**Municipal Services Center, Council Chamber
3600 Tremont Road**

Authors: Justin Milam, AICP, Senior Planner

BZAP Meeting Date: November 20, 2024

Subject: 2248 Club Road (VAR-63-24) - To allow an enclosed breezeway that connects the house with the existing detached garage, making it all one principal structure. It would reduce the minimum side yard setback from 10 feet to three, the minimum rear yard setback from 32.5 feet to five, encroach into the side yard longwall setback, and project into the rear yard profile (all existing). [The detached garage is presently used for sleeping quarters, which is not permitted.] Building cover would increase from 29.1 percent (per BZ-03-97) to 29.6 percent and development cover would increase from 48.4 percent (per BZ-03-97) to 49 percent.

Callanan Residence		
SCALE: <i>N/A</i>	APPROVED BY:	DRAWN BY: <i>DW</i>
DATE:		REVISED
Site Plan - New Breezeway		
Zoning <i>R-1C</i>	DRAWING NUMBER <i>0-1</i>

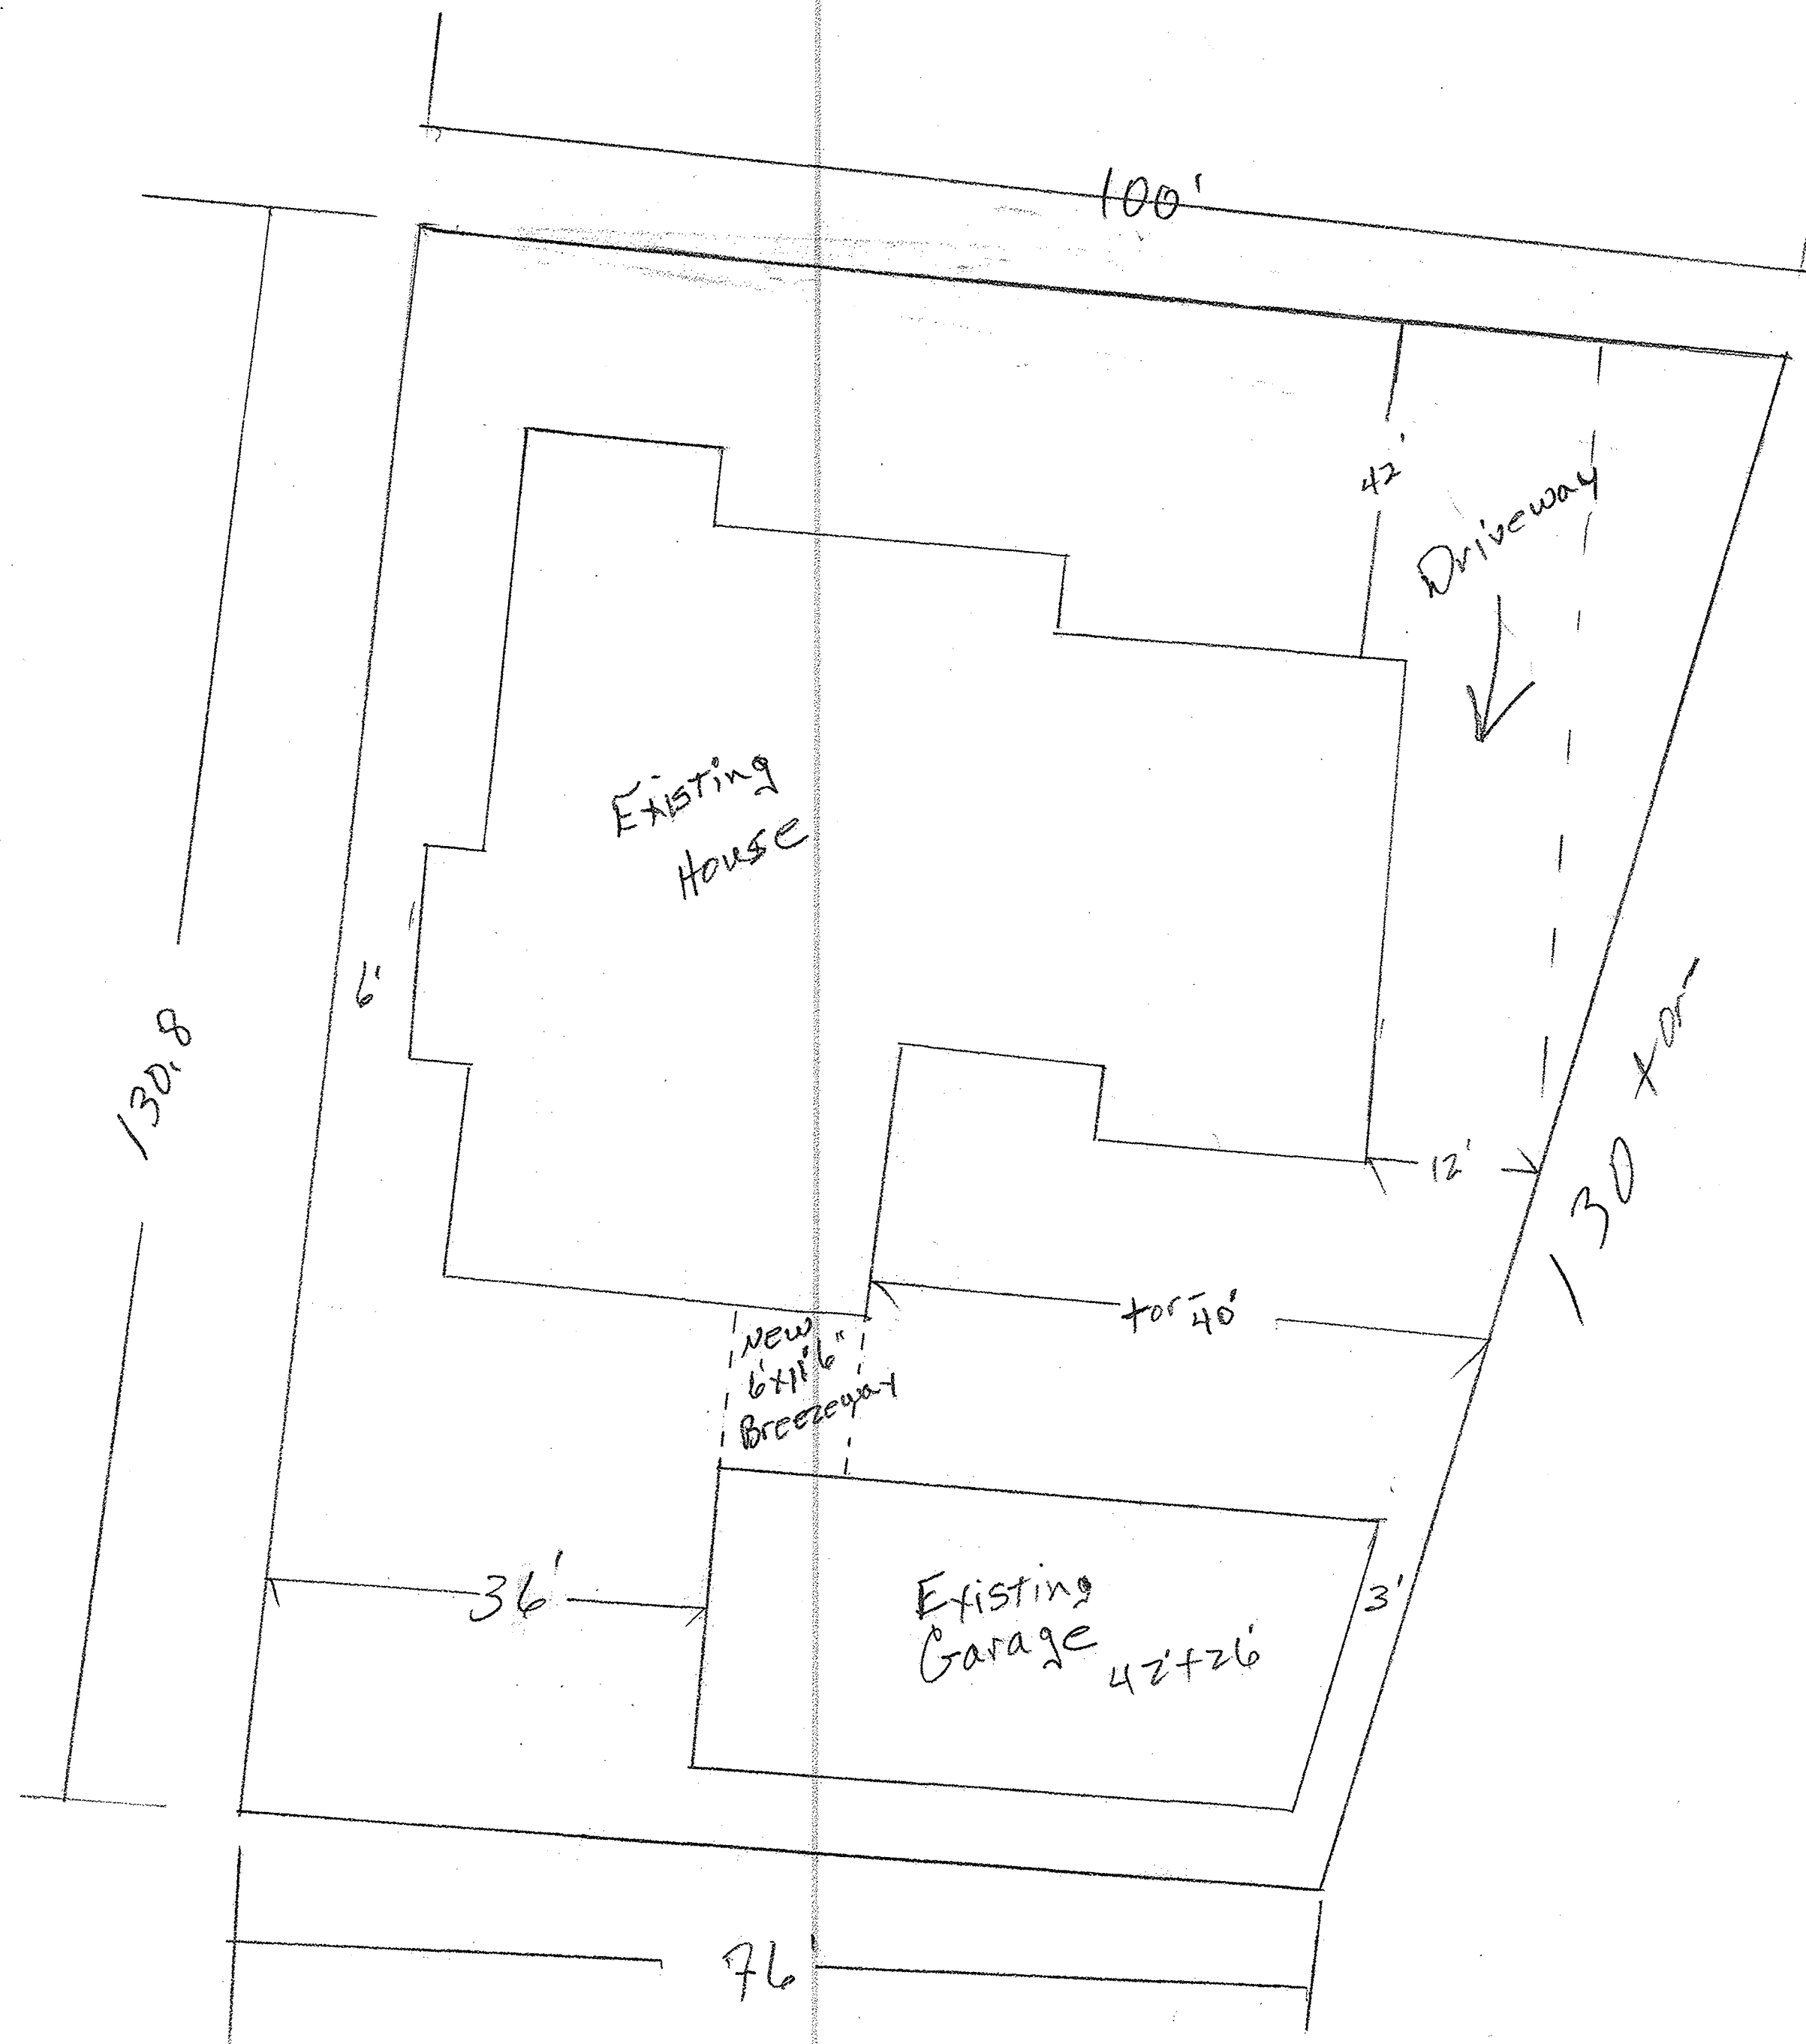
1. To allow an enclosed breezeway that connects the house with the existing detached garage resulting in a seven-foot encroachment into the 10-foot minimum side yard setback (Article 5.02);

2. To allow an enclosed breezeway that connects the house with the existing detached garage resulting in a 27.5-foot encroachment into the 32.5-foot minimum rear yard setback (Article 5.02);

Staff has reviewed the application and plans, met with the applicant, and visited the site. In this case, Staff's analysis revealed that the site is already "maxed out" with development. While the lot narrows toward the rear, the existing building and development cover ratios already exceed permissible limits. The proposal results in six (6) variances, which is unprecedented; there are other options available that would reduce the number and severity of these. Based on these facts, Staff does not support the request.

Should the Board choose to support this application, Staff would recommend that the development coverage variance be eliminated, and plans for the existing sleeping quarters located on the second floor of the rear garage be submitted for review to ensure safety/code compliance. Should the breezeway be open and not "attached", variances would still be needed for: building cover, development cover (which could be eliminated), as well as for the potentially noncompliant sleeping quarters.

Floor Plan / Floor Framing / Roof Framing			
SCALE:		APPROVED BY:	
DATE: 9/20/24		DRAWN BY: DCW	
		REVISED:	
Callanan Residence			
2248 Club Rd.		DRAWING NUMBER: 4

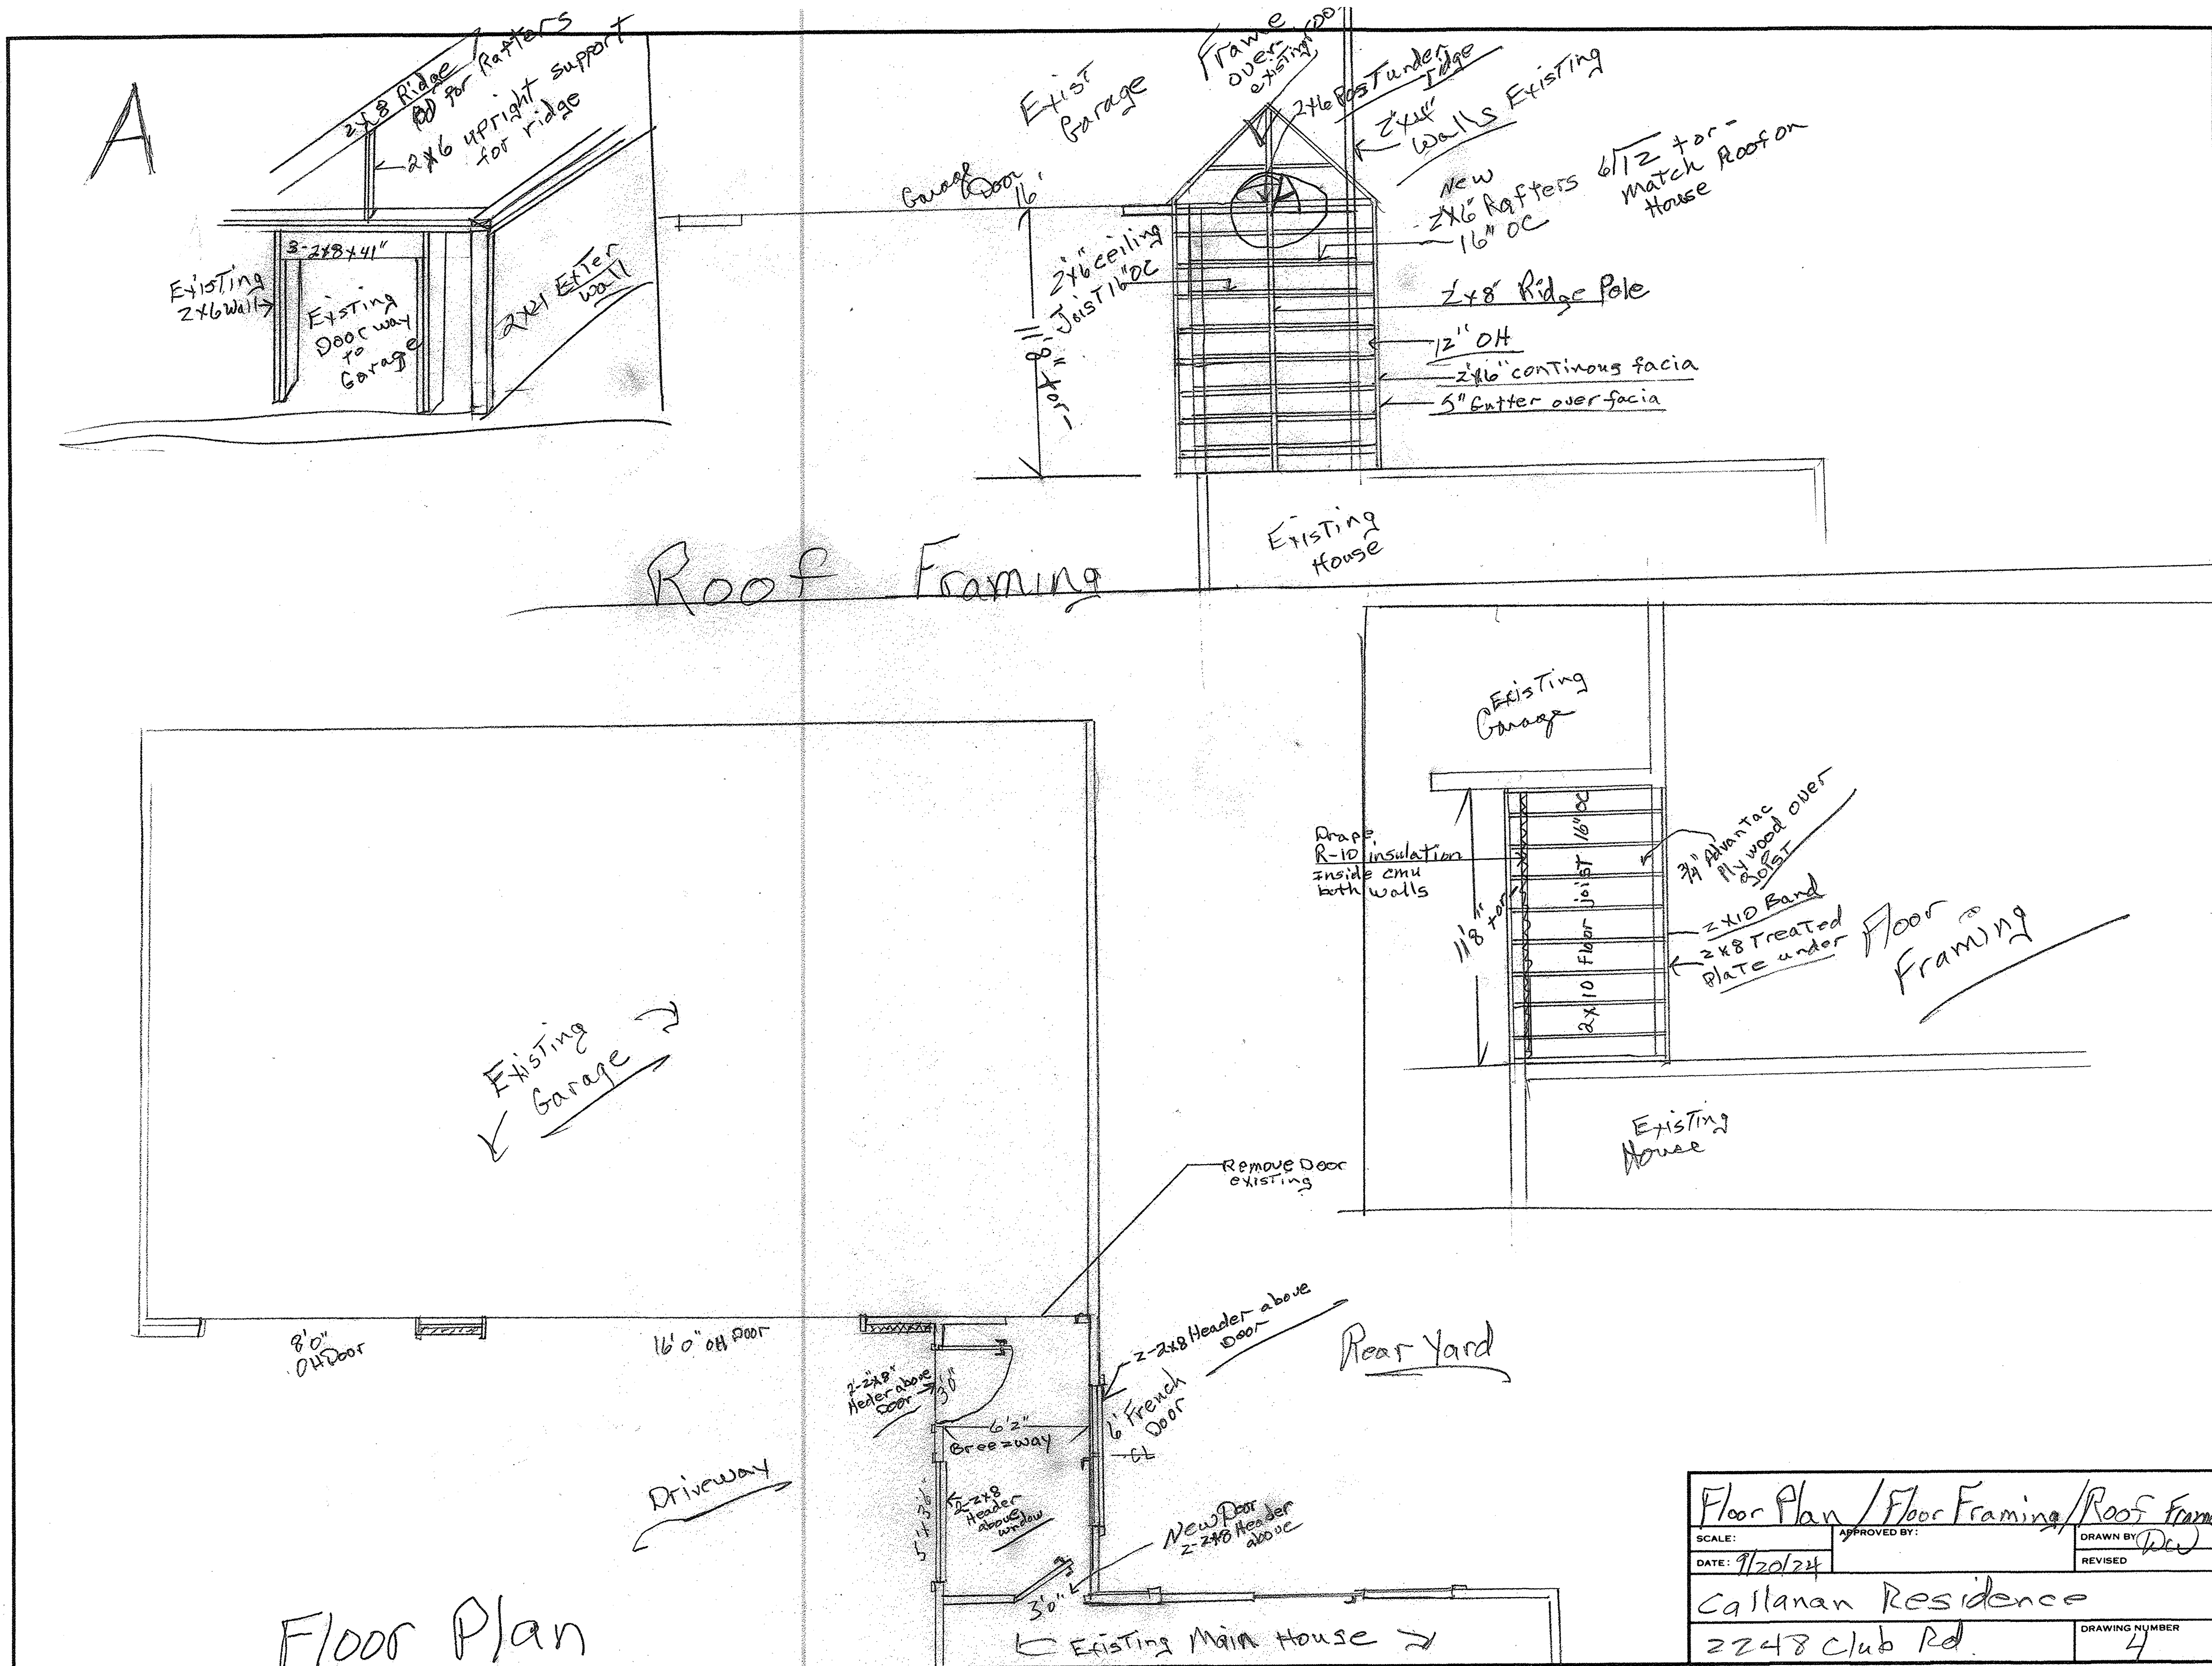
The proposal includes the construction of a one-story enclosed breezeway that would connect the existing house to the existing detached garage. It would be installed mostly atop an existing concrete patio/walkway between the two structures. It measures 6' x 11'-6" and includes a stucco exterior with a standing seam metal roof. This connection would result in several variances (see below). A mudroom would be installed inside the existing detached garage, near the stairs to the second level where a family member is residing for care. [Again, Staff could not locate City approval for this use.]

The development coverage variance could also be eliminated if the breezeway were to be installed atop the existing hardscape or if the existing hardscape elsewhere on the property were removed.

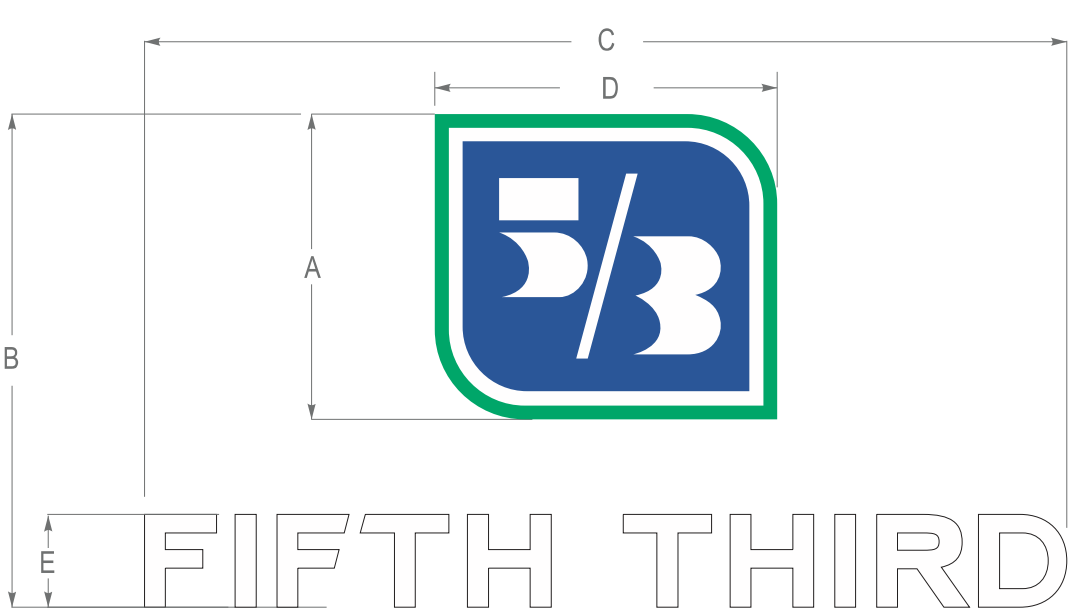
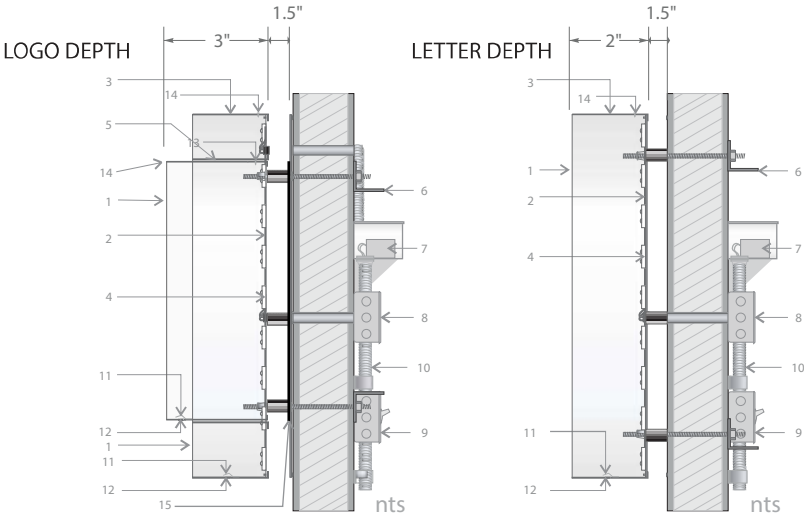
- Despite its history, that the west elevation sign that is visible on Fishinger Road be non-illuminated due to the proximity (125 feet) to a single-family residence. The applicant has offered to provide halo-lit illumination so that the intensity of light is drastically reduced. The bank does not want to lose an illuminated sign that faces the roadway and has existed for decades. The remaining signs would be internally-illuminated; Staff requested that these other signs be halo-lit for consistency. The applicant has satisfied the request.

Update: The applicant has revised all the proposed building-mounted signage to be halo-lit.
